Reference: 20.456r05v02

**Re: TRAFFIX Response to Review of Response to Submissions
TAFE NSW Institute of Applied Technology for Construction
2-44 O'Connell Street, Kingswood (SSD 8571481)**

TfNSW Exhibition of EIS Dated 24th June 2021 - Attachment A

Penrith City Council Response to Submissions Dated 24th June 2021

Chart 1: AADT along Great Western Highway 2015 -2021

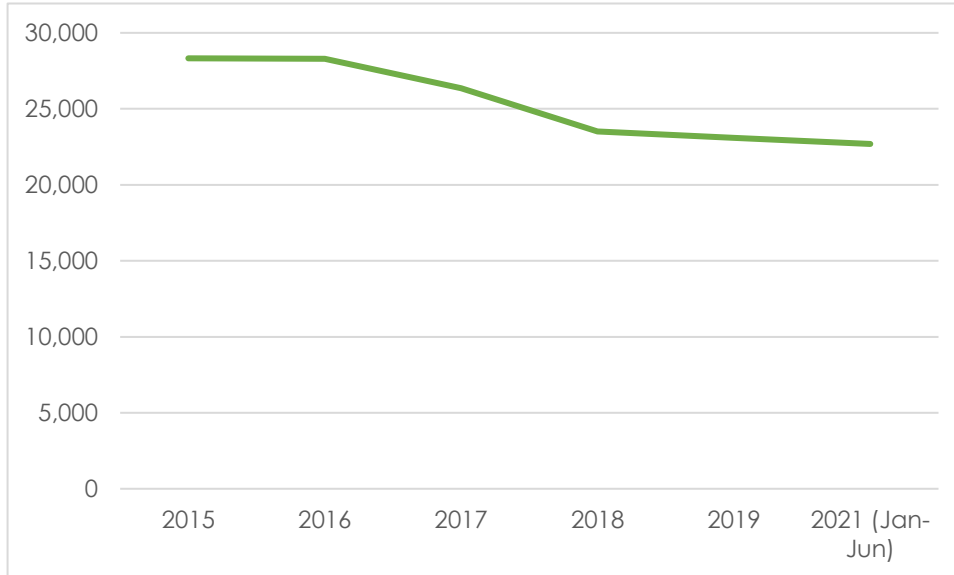
TfNSW notes that the updated SIDRA Intersection 9 modelling indicates that the queue length of the right turn bay at the Great Western Highway / French Street / O'Connell Street intersection exceeds the length of the bay by approximately 10 metres during the 95th percentile in 2030 + development.

Whilst it is understood that the GTP car driver target of 69.3% by 2030 is being proposed, there is a current project as part of the Federal Stimulus Program at the intersection of Great Western Highway / French Street / O'Connell Street. The project scope will provide right turn red arrow pedestrian protection for traffic turning from French and O'Connell streets as well as providing the missing pedestrian legs. The project designs are currently being developed, however the abovementioned scope has been identified. These changes to the intersection will likely result in

longer delays and queue lengths. Which when including the extra development traffic predicated this may result in the queues for the right turn bay exceeding the length of the bay earlier than expected.

It is therefore recommended that the right turn bay on the western leg of Great Western Highway (GWH) is extended to accommodate the increased traffic expected as a result of this development. Subject to DPIE's approval, TfNSW requests that the following requirement to be included in the development consent:

TRAFFIX Response: The background traffic growth rate assumed for the Traffic Impact Assessment (reference: 20.456r02v08) is considered an overestimation which was adopted as a worst case scenario and has resulted in the queue length of the right turn bay at Great Western Highway onto O'Connell Street slightly exceed the existing right turn bay during the morning peak period and is unlikely to occur under normal future peak conditions. In fact, the traffic along the Great Western Highway has been decreasing by 20% over the past 7 years based on data from the Permanent Classifier counter at the intersection of Great Western Highway and Pages Road (Station ID 7123-PR). The data provided in **Table 1** shows the weekday annual average daily traffic (AADT) for each year since 2015 and **Chart 1** further emphasises the declining trend. The data for 2020 was excluded due to the impact of the COVID-19 lockdown and the 2021 data considers the traffic before the current lockdown.

Based on the above further analysis, it is considered reasonable to reduce the growth rate from 2% to 0% having regard for declining long term traffic volume trends along this corridor. On this basis, the 2030 scenario has been reassessed at the critical intersection of the Great Western Highway, O'Connell Street and French Street. The model retains the previous travel modes for the trip distributions including the 84% of students/staff driving to TAFE. However, the Green Travel Plan is premised upon a car driver target of 69.3% by 2030 through the use of a number of strategies to encourage alternative transport modes. This applies to the entire future TAFE student population, including existing students, which will significantly suppress travel demand by private cars.

Drawing Title
 O'Connell Street Access Driveway
 Swept Path Analysis
 12.5m HRV - Site Access & Passing Opportunity
 Left: HRV Entry Manoeuvre from North
 Right: HRV Egress Manoeuvre to South

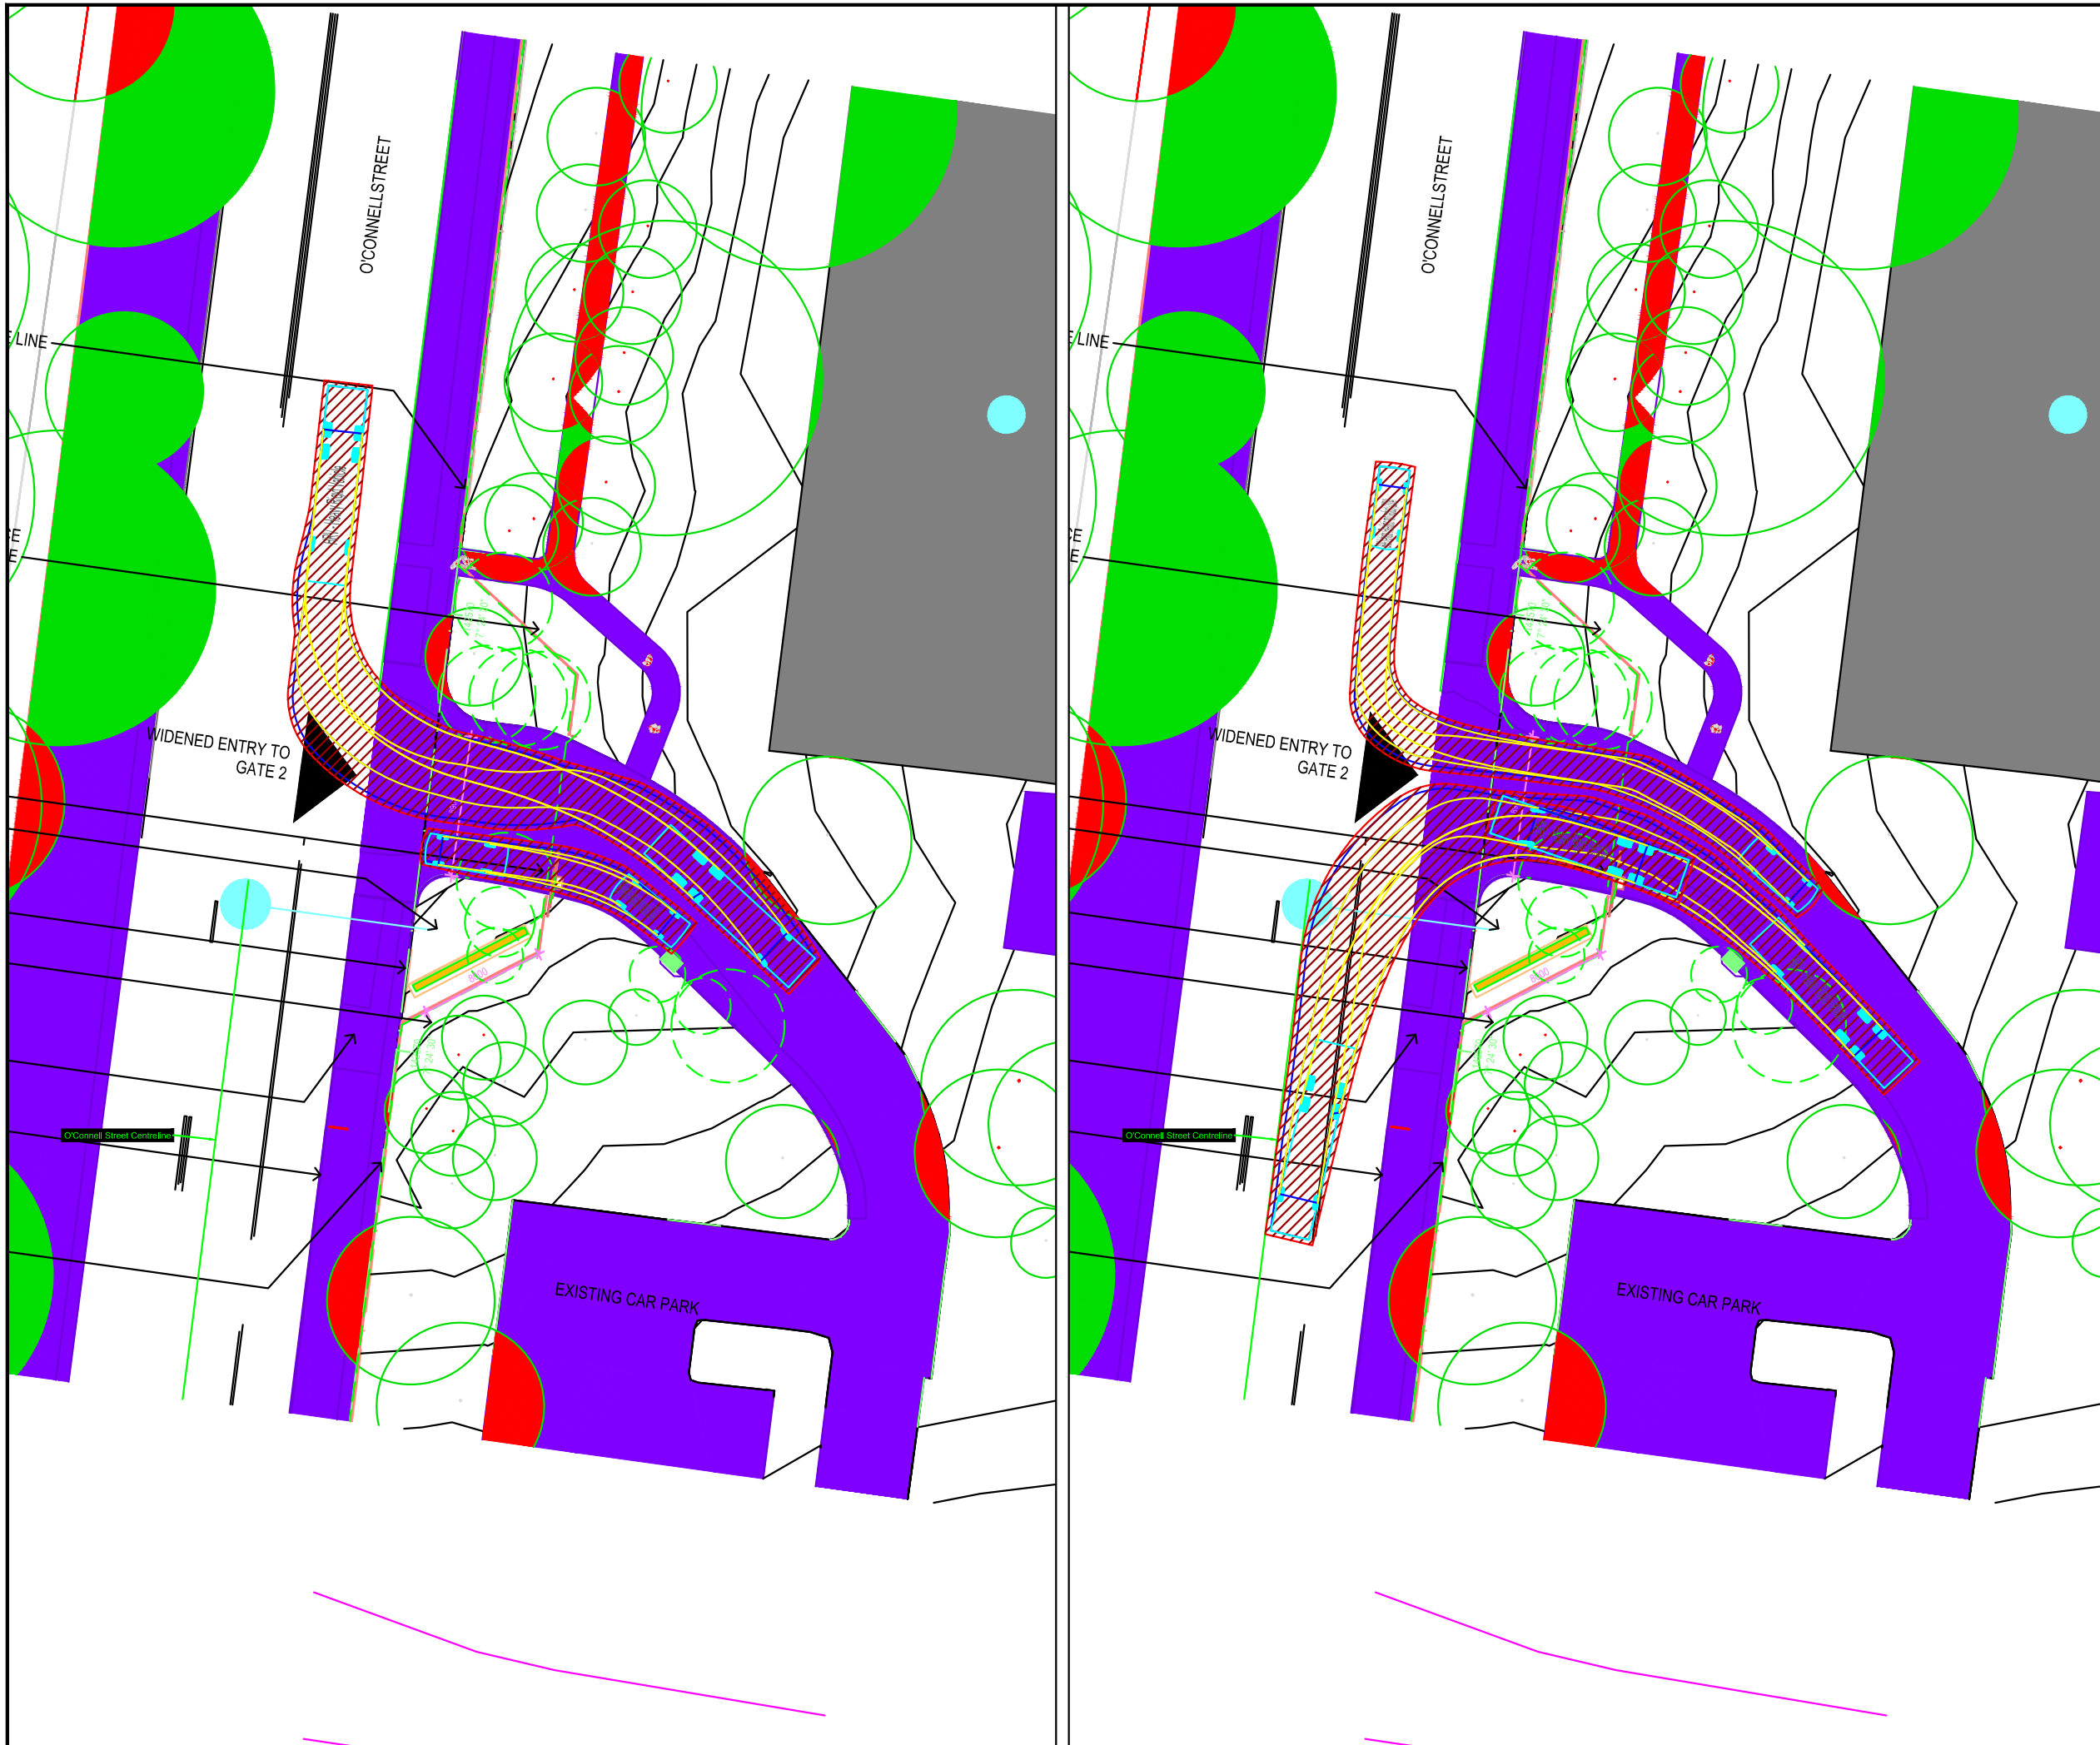
The swept path movements for a 12.5 metre vehicle at O'Connell Street indicate that simultaneous entry/exit cannot be achieved. This can lead to conflict points at the access where 2 opposing vehicles are attempting to use the access at the same time. It is noted that minor works to remove the median (in driveway) and widening of the internal road are proposed. This could extend to the widening at the entrance of the driveway to allow for simultaneous entry exit.

The design of the access point should be widened to allow for simultaneous entry/exit movements of the largest vehicle with a passenger vehicle. However as O'Connell Street is a Local Road, Council is to determine if the development risks raised by TfNSW is satisfactorily addressed by the applicant. Should the driveway be widened the swept path of the longest vehicle entering and exiting the subject site, shall be in accordance with AUSTRROADS and to the satisfaction of Council.

TRAFFIX Response: Reference should be made to the swept path analysis provided in **Attachment 2** showing the amended southern access driveway layout via O'Connell Street which accommodates the largest size vehicle being a 12.5 metre heavy rigid vehicle (HRV) passing a B99 design vehicle at the site boundary. The amended access driveway has been designed in accordance with AS2890.1 (2004) and AS2890.2 (2018). It is noteworthy that the access driveway is not subject to Austroads Guidelines as it is a private driveway and is required to be assess with the requirements of AS 2890.1 and AS 2890.2 in this regard. Notwithstanding, it is emphasised that any requirement for a 12.5m HRV to pass a B99 design vehicle at the driveway crossover will be minimal since HRV's are expected to access the subject development approximately once every two (2) weeks and will arrive and depart outside of TAFE student peak times. The amended vehicle crossover will comfortably accommodate all vehicles accessing the subject site under all scenarios.

SIDRA 9 Intersection Output
O'Connell Street / Southern Site Access

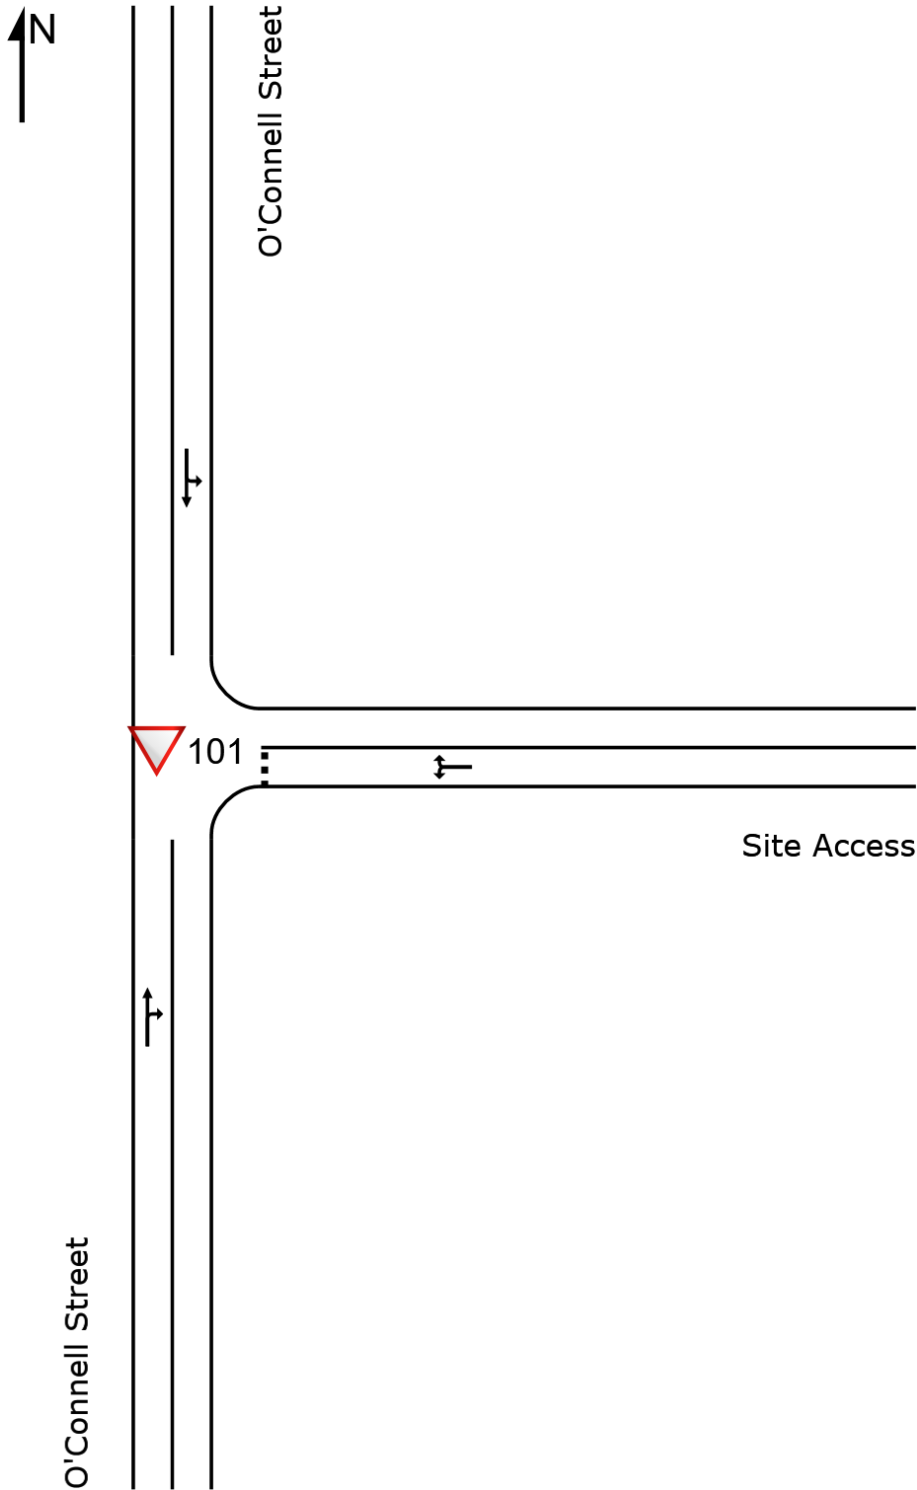
- Assessment of potential need to upgrade existing driveway access as unsignalised intersection with regard to Austroads Guide to Road Design basic turn treatments or auxiliary lane treatments needed?
 - Sight distances for vehicles exiting site
 - Sight distances for vehicles approaching queued/propped vehicles on O'Connell Street
 - Auxiliary turning lanes needed? – deceleration/acceleration
 - Warrants for turn treatments on the major road at unsignalised intersections (Warrants for BA, AU and CH Turn Treatments)
 - Vehicle turning volumes in vph (existing and proposed growth)
 - Meets minimum stopping sight distances (min. SSD)
 - Queue lengths
 - Up to date relevant traffic volume surveys for O'Connell Street and site access

The existing southern access driveway via O'Connell Street was modelled using SIDRA 9 Intersection modelling software to assess the traffic impacts at this intersection in relation to the 2030 development scenario. SIDRA 9 Intersection modelling results for the existing and future scenarios during the peak TAFE morning and afternoon periods are presented in **Table 2** below:

It can be seen from **Table 2** above that the access driveway operates at a Level of Service A under the existing and 2030 + development during both morning and afternoon peak period scenarios, demonstrating that the southern access driveway will continue to operate at a good operational level with an average delay of no more than 10.7 seconds during network peak times. Therefore, the driveway access will continue to operate satisfactorily. Reference should be made to the SIDRA 9 Intersection modelling results presented in **Attachment 3** for reference.
